CLAREMONT BUSINESS PARK 2 FILING NO. 2

FINAL PLAT
CLAREMONT BUSINESS PARK 2 FILING NO. 2
JOB NO. 10-020
DATE PREPARED: 02/27/2023
DATE REVISED: 04/10/2023

V2_Final Plat.pdf Markup Summary

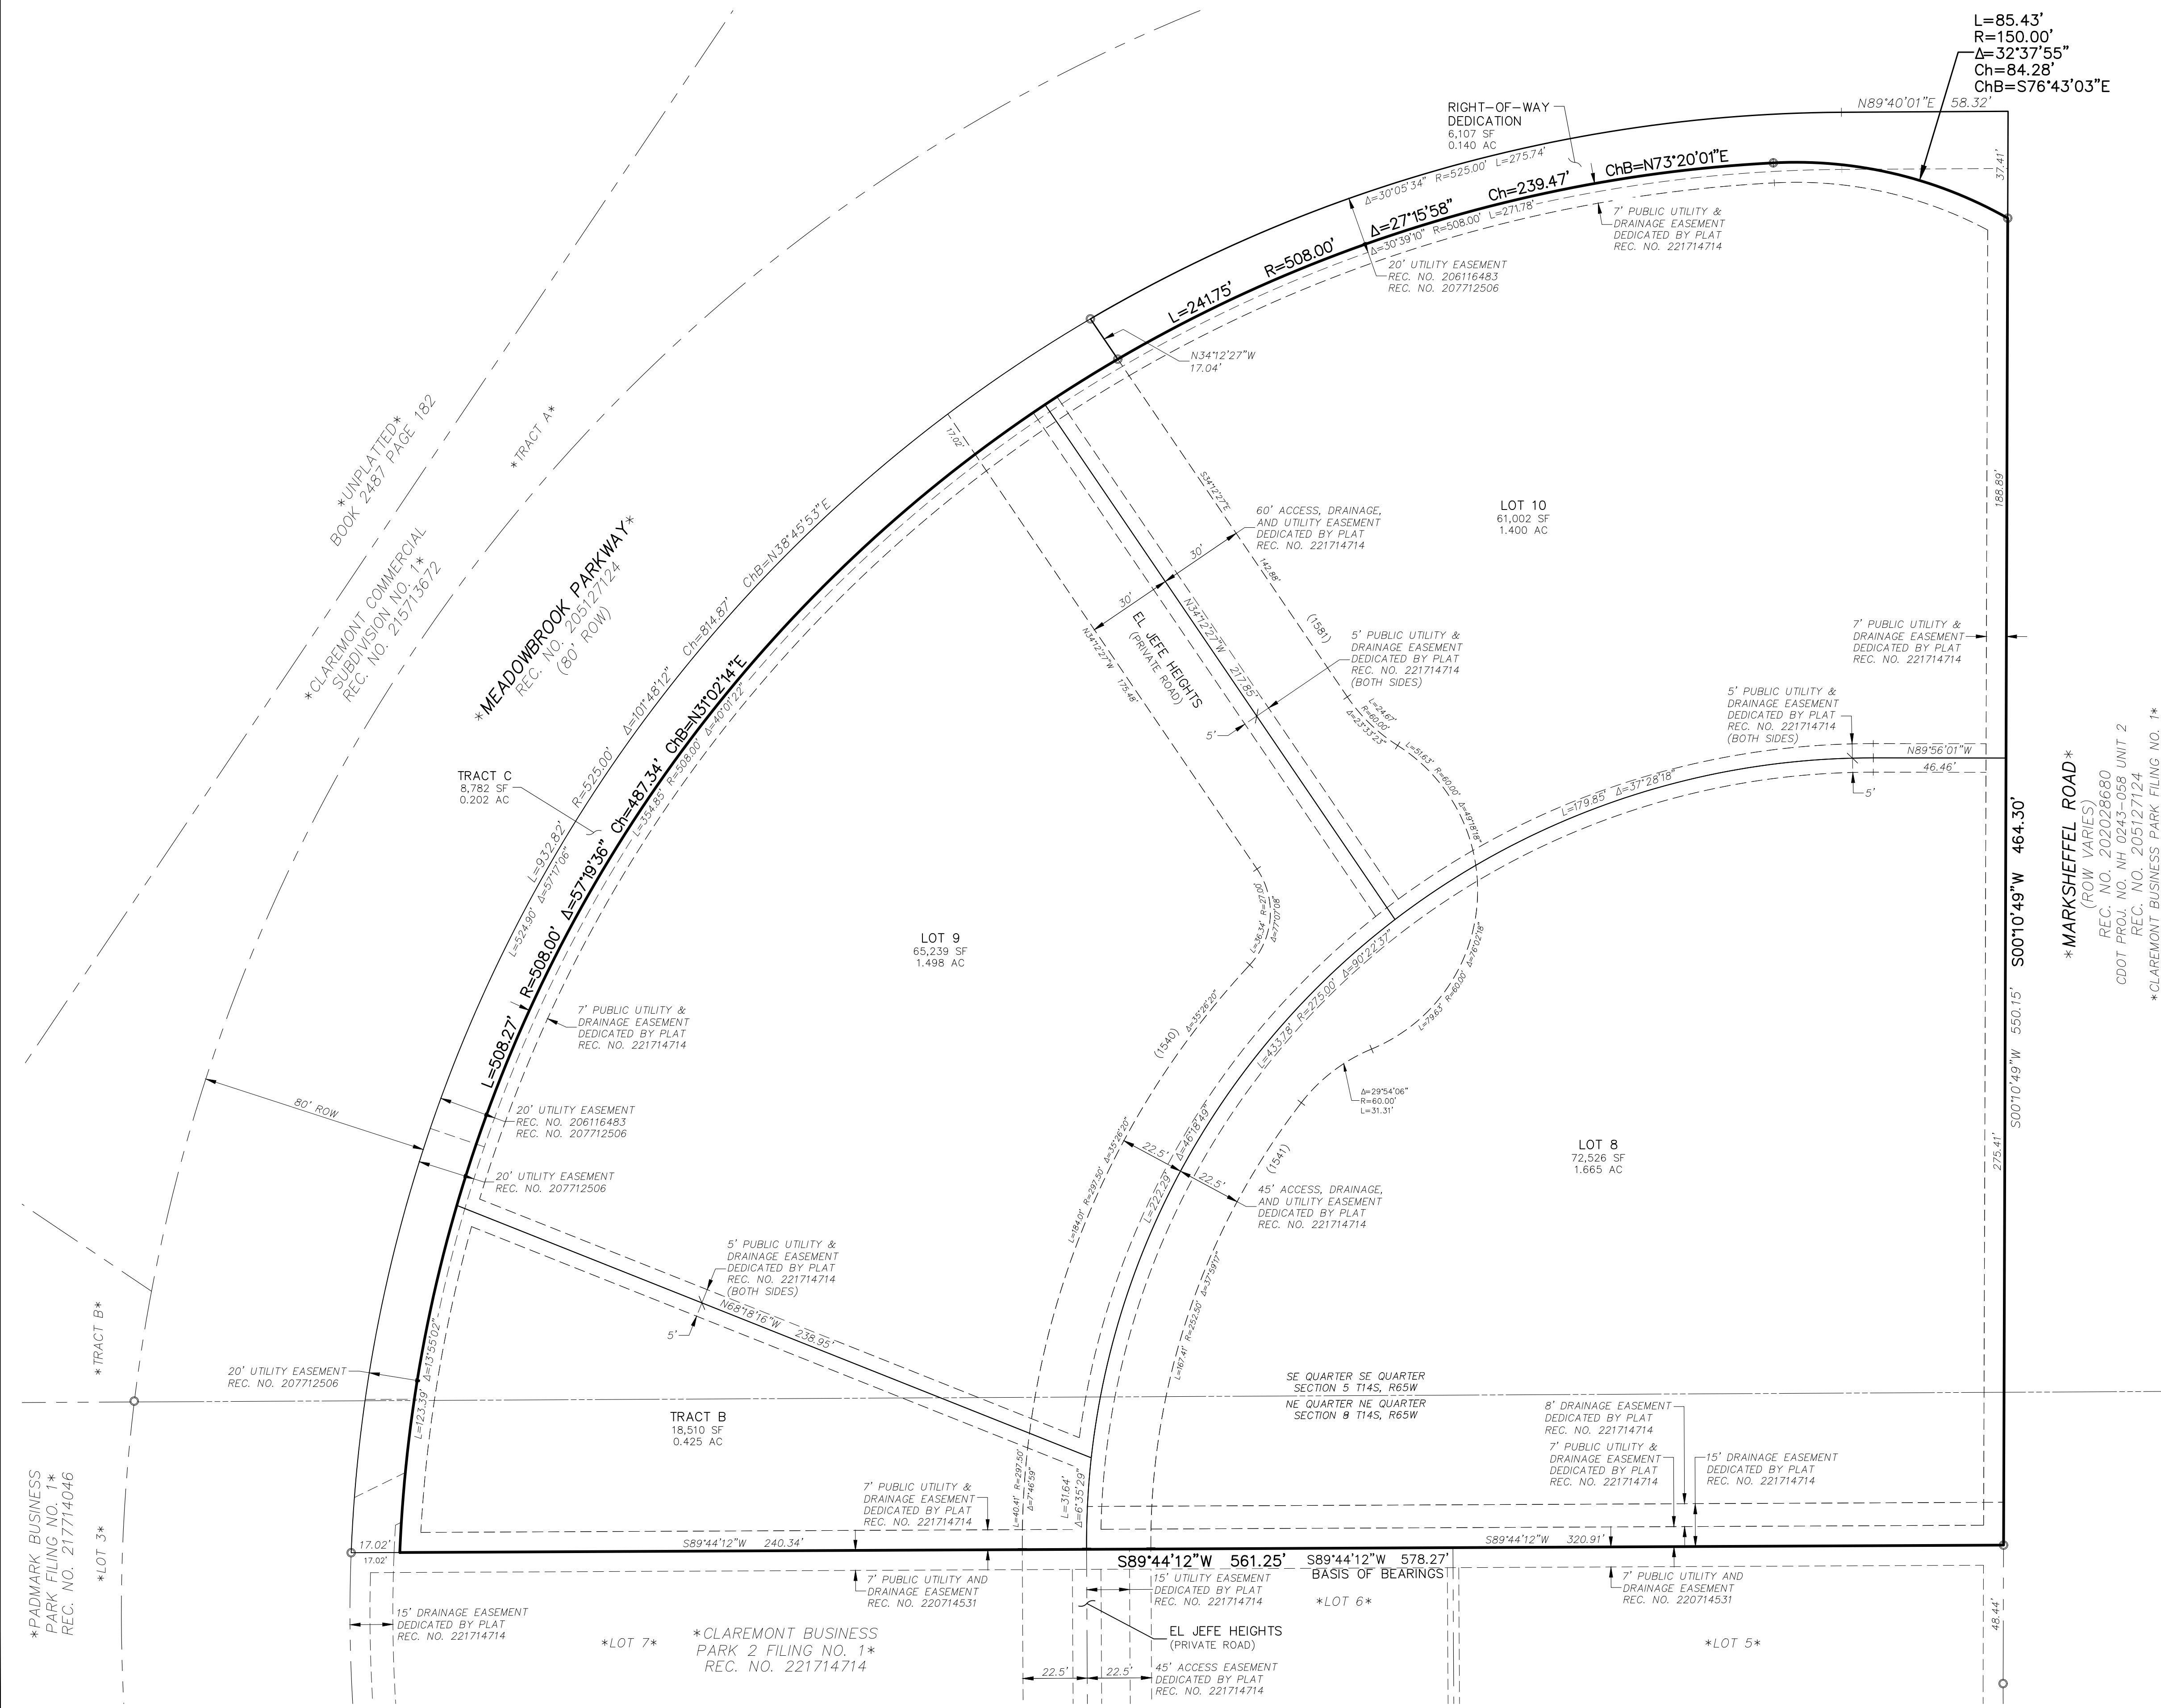
Note 12 is a duplicate of note 8, please remove.

Note 12 is a duplicate of note 8, please remove.

AS REPLATTED

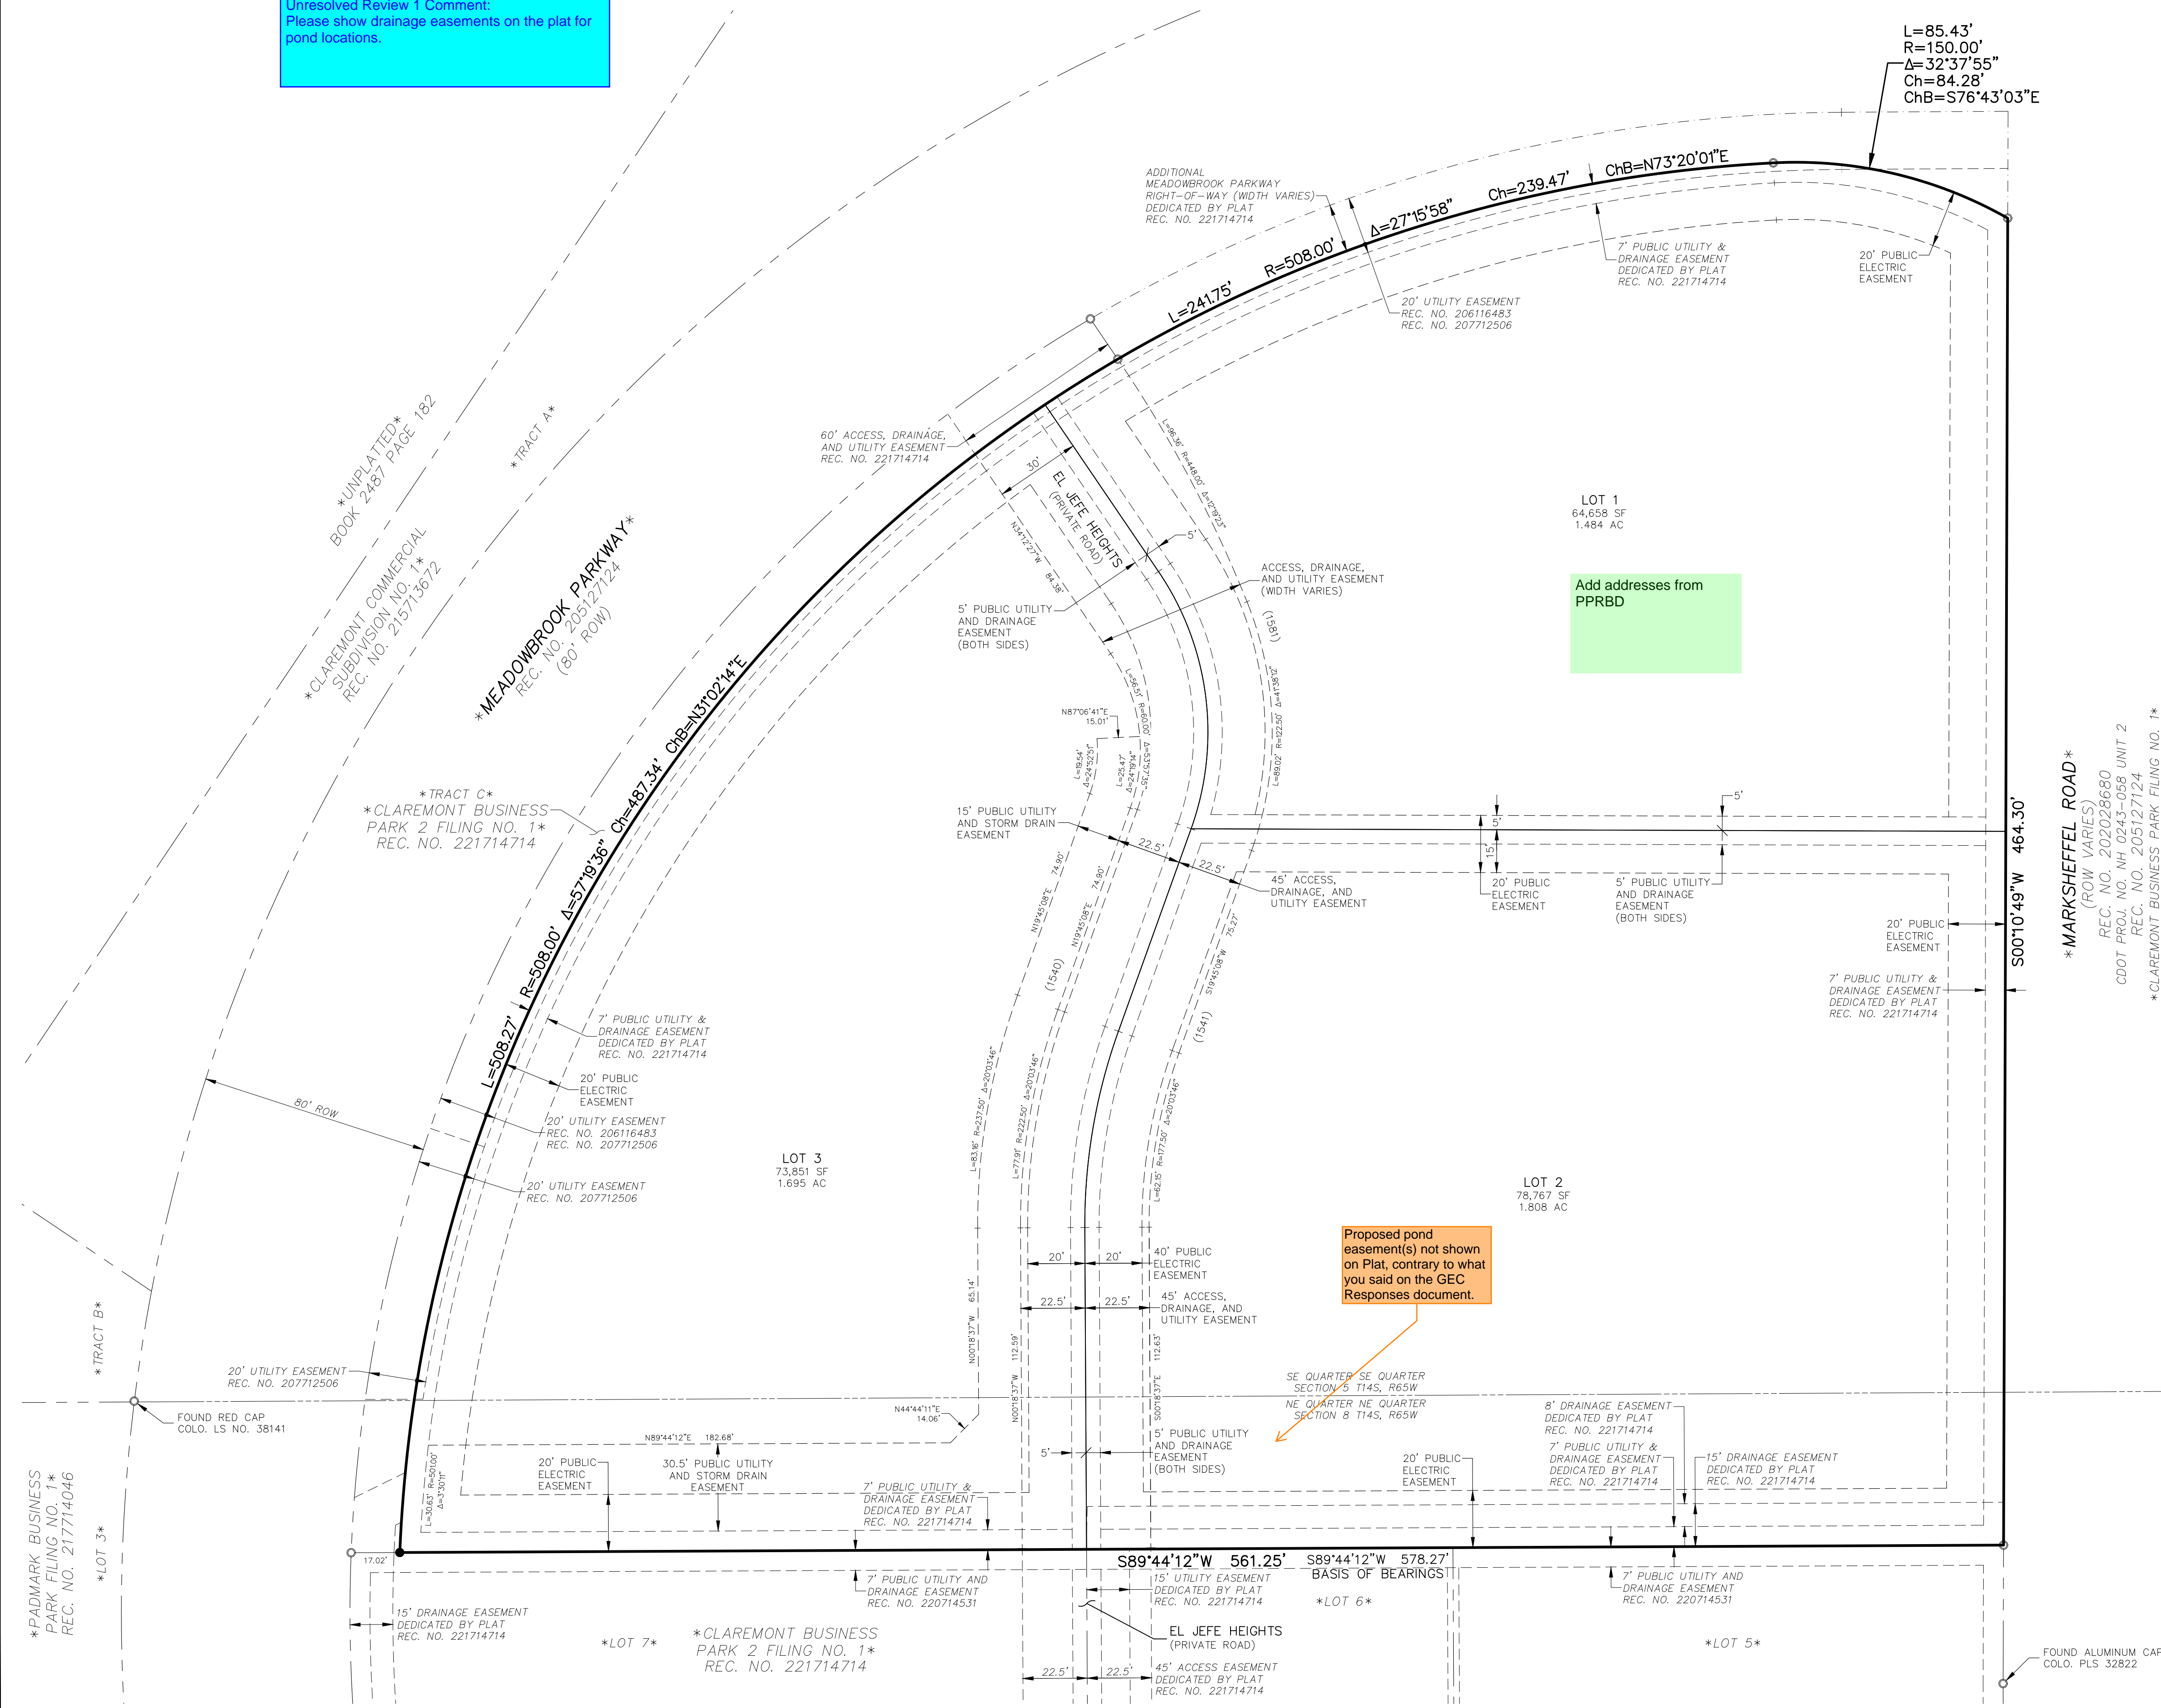
Unresolved Review 1 Comment:
Please show drainage easements on the plat for pond locations.

Add addresses from PPRBD

Proposed pond easement(s) not shown on Plat, contrary to what you said on the GEC Responses document.

Unresolved Review 1 Comment:
Please show drainage easements on the plat for pond locations.
